Your Reference	SSD8873789
Our Reference	NCA/5/2020
Contact	Kate Lafferty
Telephone	9806 5393
Email	klafferty@cityofparramatta.nsw.gov.au

**COUNCIL COMMENTS – RESPONSE TO EXHIBITION
86 Chelmsford Avenue, Epping (New Epping South Primary School)**

Figure 1: Potential pedestrian access from Ferntree Place increasing walkable catchment to school.

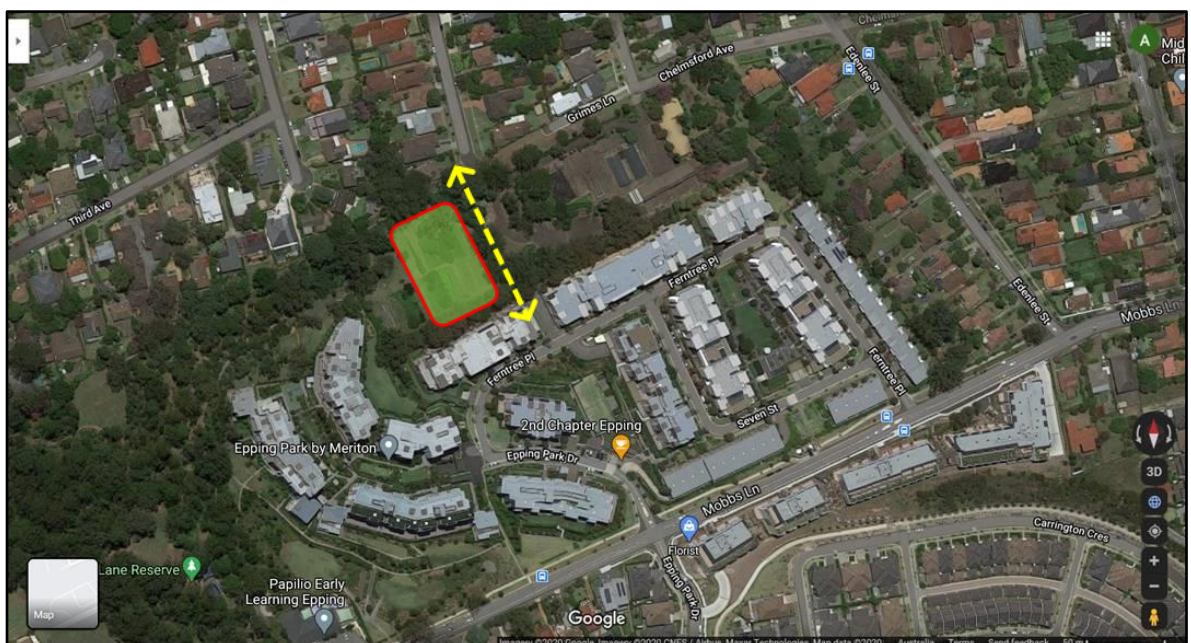
Concern is raised with the lack of pedestrian access to the future school facility from the south of the subject site. The school catchment in terms of pedestrian access seems to be only to the north of the subject site. As a minimum, pedestrian access to the school grounds should be located to the southern boundary accessed from Ferntree Place. This will significantly increase the walkable catchment of the school and reduce dependence on car drop-offs.

Whilst it is acknowledged that there is an existing private residential development adjoining the southern boundary, an accessible link from Ferntree Place and the cul-de-sac at Second Avenue is also possible. In addition to a through site link this affords greater after-hours community access to the proposed play areas (refer to Figure 1 below).

Figure 2: Leichhardt Secondary School has a cycleway/pedestrian link from Moore Street W to Balmain Road allowing permeability for the general public. (Source: [Google Maps](#))

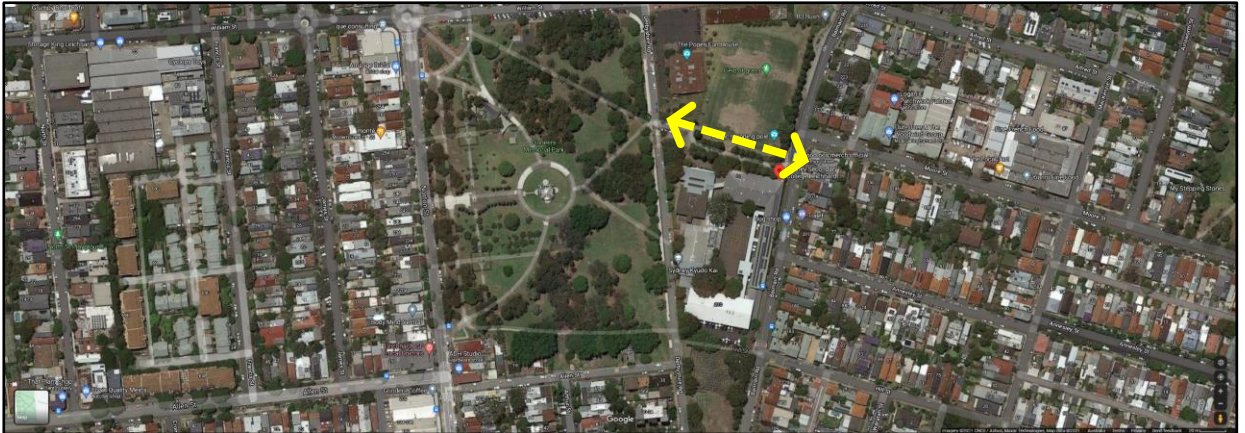
Figures 2 & 3 below indicate the Leichhardt Secondary School which allows such a connection for improved permeability and shared use of the playing field. Council officers recommend this approach be adopted in this proposed school.
